**EXPLANATION OF SIGNIFICANT DIFFERENCES
TO THE
RECORD OF DECISION**

OPERABLE UNITS 2 AND 9

**NAVAL AIR STATION SOUTH WEYMOUTH
WEYMOUTH, MASSACHUSETTS**

February, 2012

ESD Project Plan

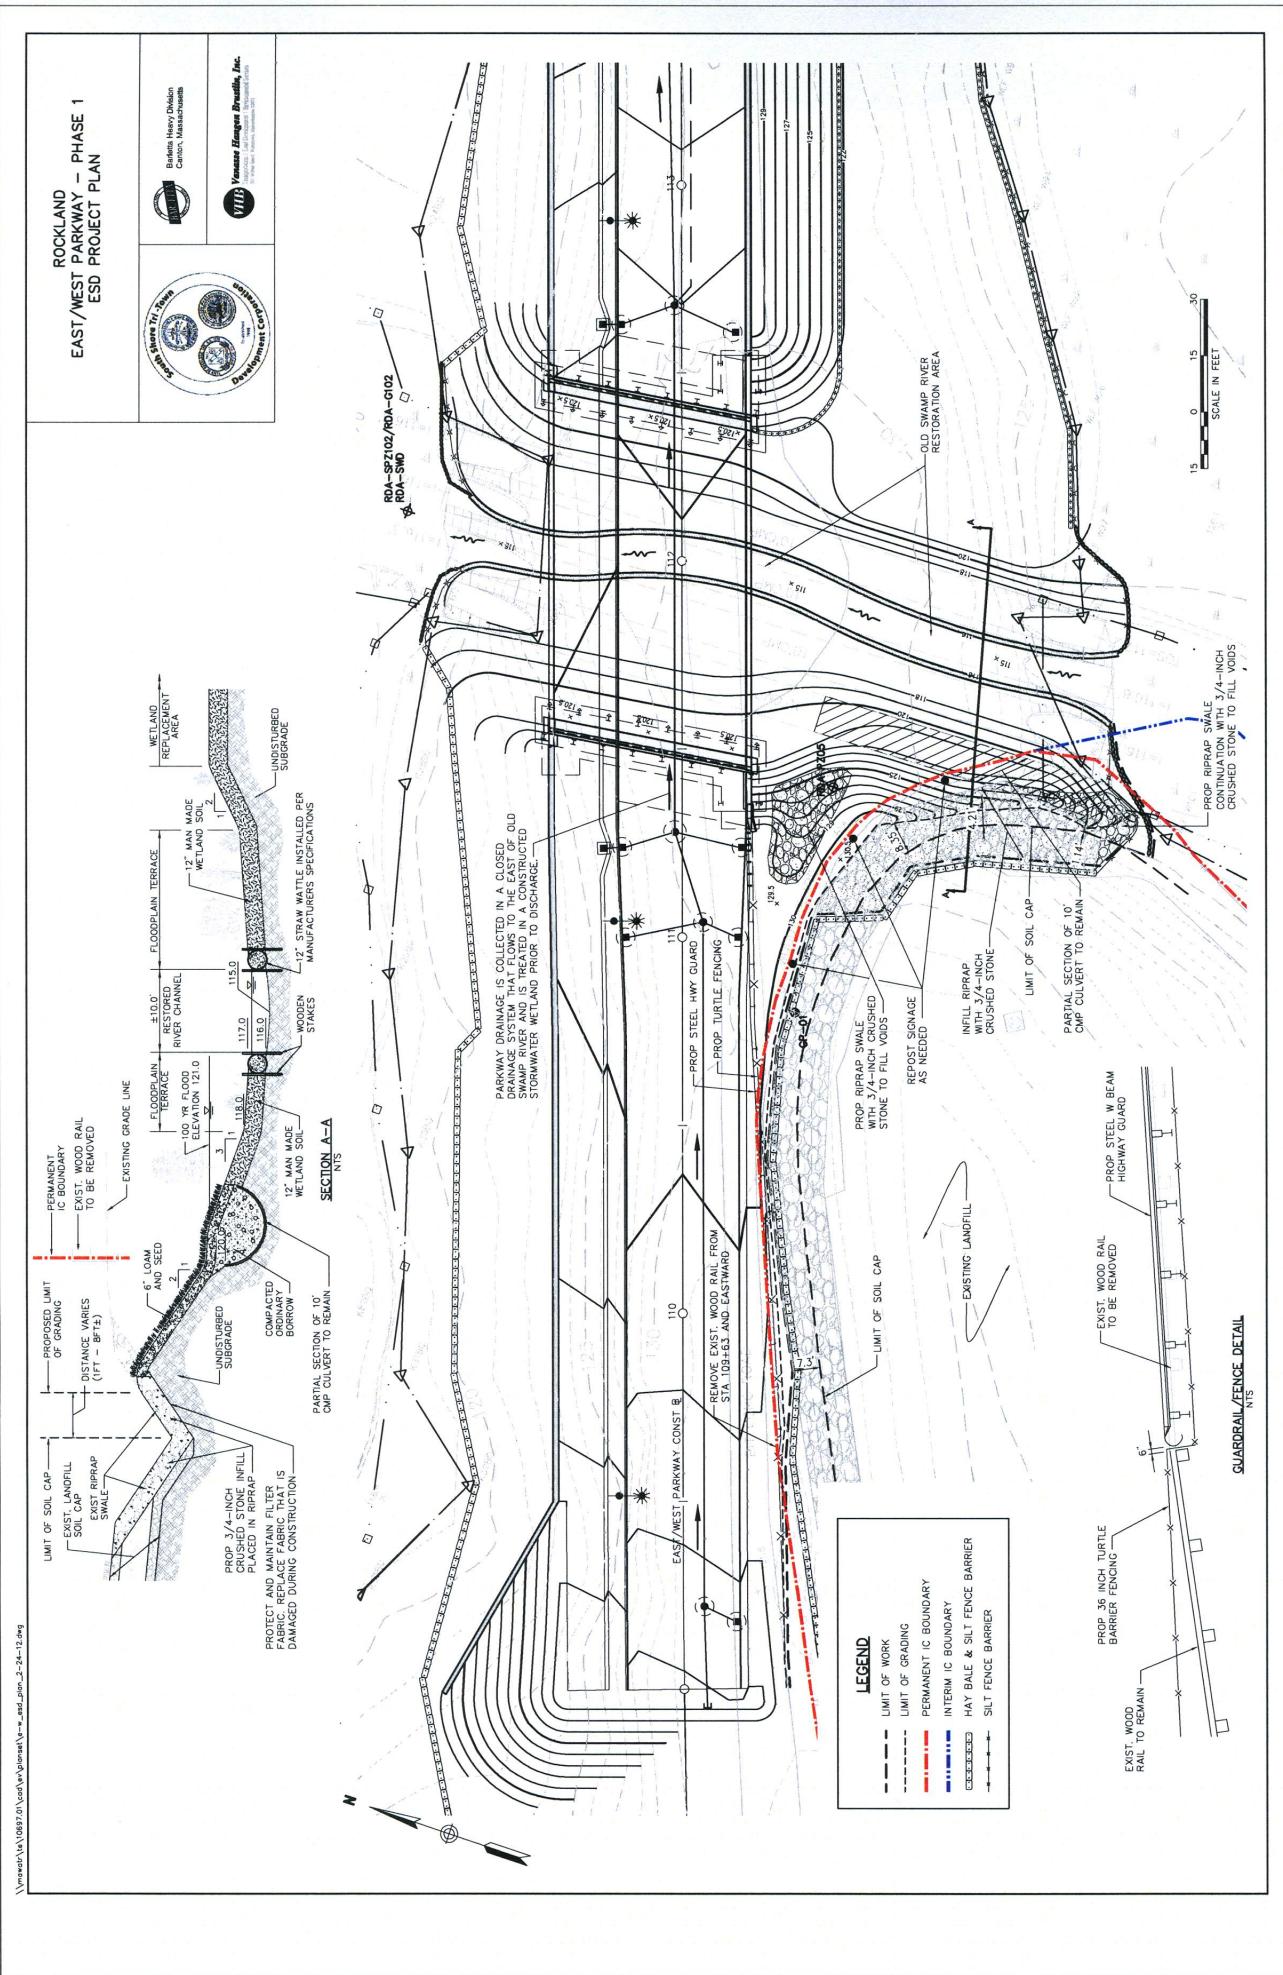
7	Sec AA	Why is the River Channel shown with a width of 10 feet? The river channel shown in the figure scales to 6 feet?	10 feet is the correct number. The figure was not drawn to scale. It has been revised to scale to the correct dimension.
Joanne Marques: 60 Circuit Road, South Weymouth, MA 02190 – 12/9/11			The Navy's ROD selected institutional controls in the form of Land Use Controls as a component of the final remedy for the RDA to prohibit activities or uses of the site that would disturb or otherwise interfere with the integrity or effectiveness of the Cap. These Land Use Controls are contained in the Land Use Control Implementation Plan (October 2009). The LUCIP boundaries were established to ensure the effectiveness and integrity of the remedy. There is no further "setback" requirement from the LUCIP boundary. The Parkway is located outside of the LUCIP boundary.
1	-	Why isn't there a setback requirement associated with the construction of a major roadway abutting a capped hazardous waste landfill site?

7	-	The maps aren't acceptable and the map they claim is the "existing conditions" is false. The lighting fixtures for aircraft are the wrong ones. The objects on the lighting road never existed. This section of the east-west parkway exists in the former Naval Air Station South Weymouth; not the Town of Rockland like the map suggests. The Town of Rockland does not have authority in this section of the Naval Air Station South Weymouth.	The aerial photography used on the presentation maps was not altered, and was obtained from reputable public sources. Any references to the Town of Rockland will be removed.

No.	Sheet	Comment	Response
8	-	The "proposed map" as well as the "existing conditions map" has insufficient explanations. This is unacceptable. You have "proposed a wetland replication area" where you wiped out the wetlands and CVP#3382. "The proposed constructed storm water wetland" is already a wetland. You do not show the bridge (which is in close proximity to the Old Swamp river bridge) over this wetland. There were fifteen light fixtures between Old Swamp River and this bridge.	See prior response. No wetlands were impacted to construct the stormwater wetland, nor the wetland replication area. The limits of both were designed to stay outside of the existing wetland limits.
9	-	This parkway can be moved so as not to impact the Rubble Disposal Area Superfund Site. The RDA superfund Site has been known to the developer before any design of the parkway existed.	The alignment of the roadway was designed and approved by all applicable permitting agencies to minimize impacts to regulated wetlands, upland eastern box turtle habitat, and the RDA. Moving the roadway to the north would create unacceptable impacts to regulated wetlands.
